**From:** Gwyn, Dealis W. [mailto:DWGwyn@moxproject.com]  
**Sent:** Tuesday, March 23, 2010 3:41 PM  
**To:** Tiktinsky, David  
**Subject:** Files and Responses to MPQAP Rev 9 Review Questions

Attached are draft responses to the clarification questions on draft MPQAP Rev 9. Also, attached are associated draft LA change pages.

## 4.0 ORGANIZATION AND ADMINISTRATION

Figure 4-1. MFFF Functional Organization

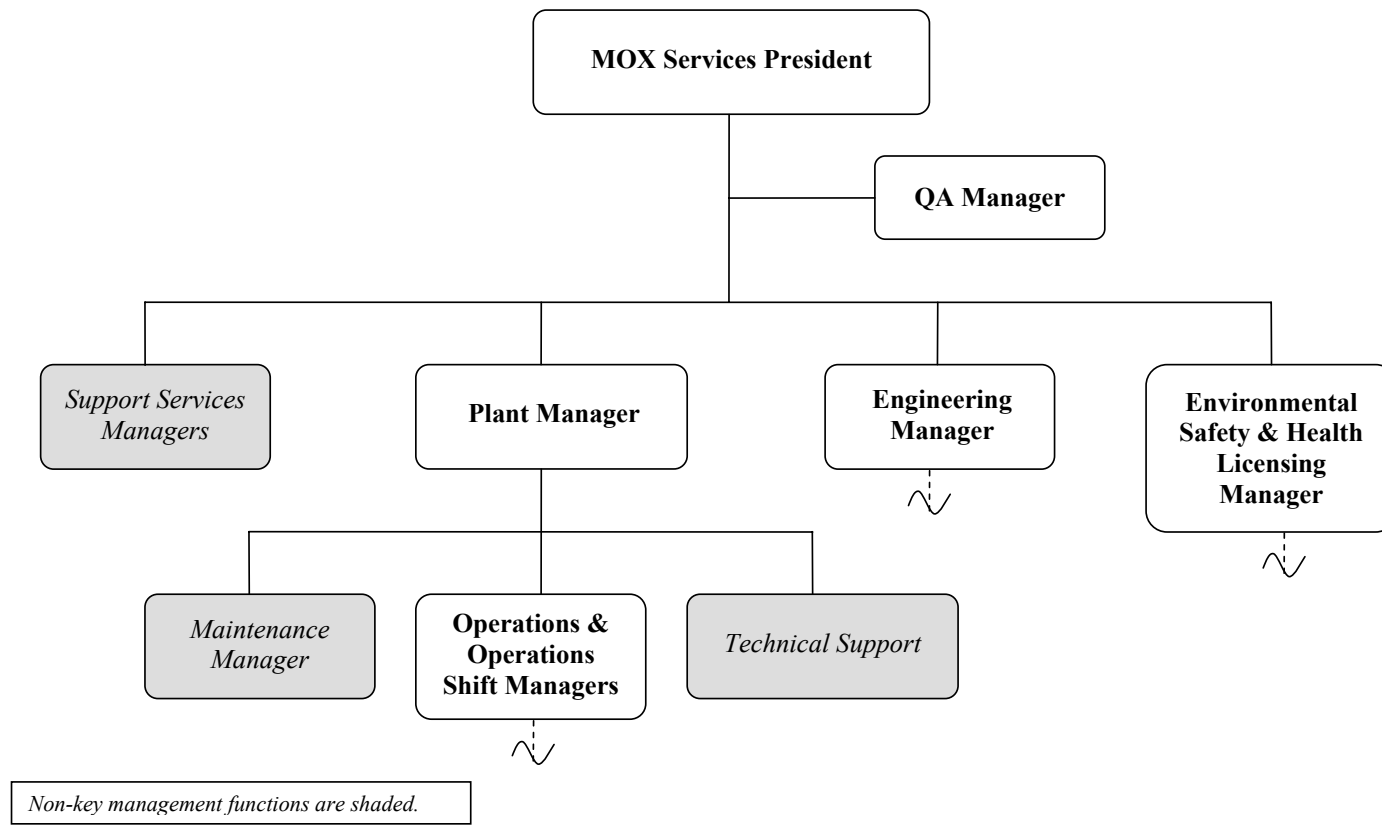
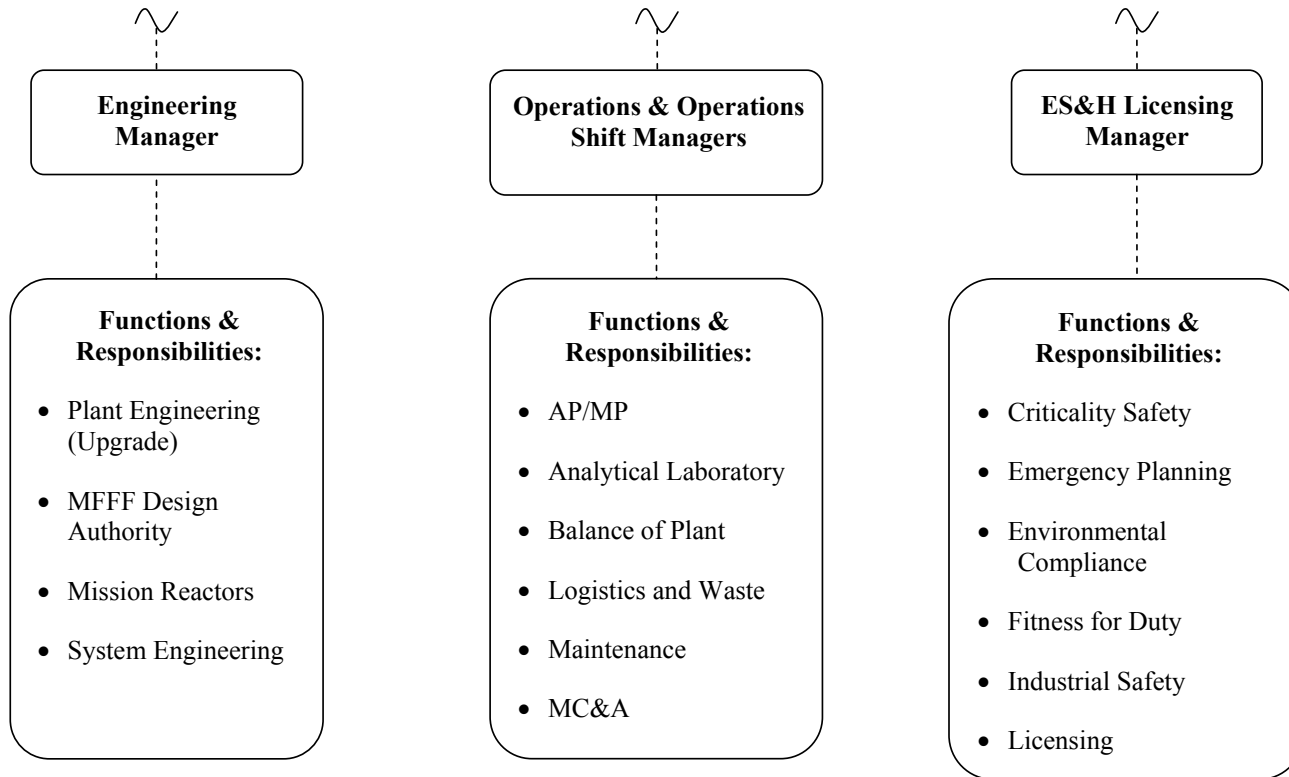
Please clarify the applicability of the MOX Organization structure shown in Figure 1.1 and how this organization is consistent with that identified in Chapter 4 of the License Application.

3. Please clarify why there is no line of reporting access shown between the QA Manager and the President of MOX Services in Figures 1-1 and 1-2.

MOX Services Response: The QA Manager as shown on Figure 1-2 as well as the QC Manager both report directly to the Manager QA/QC (new) who reports directly to the Manager Project Assurance. The Manager QA/QC (new) has a dotted line directly to the President of MOX Services. Organization chart has been revised to reflect this.
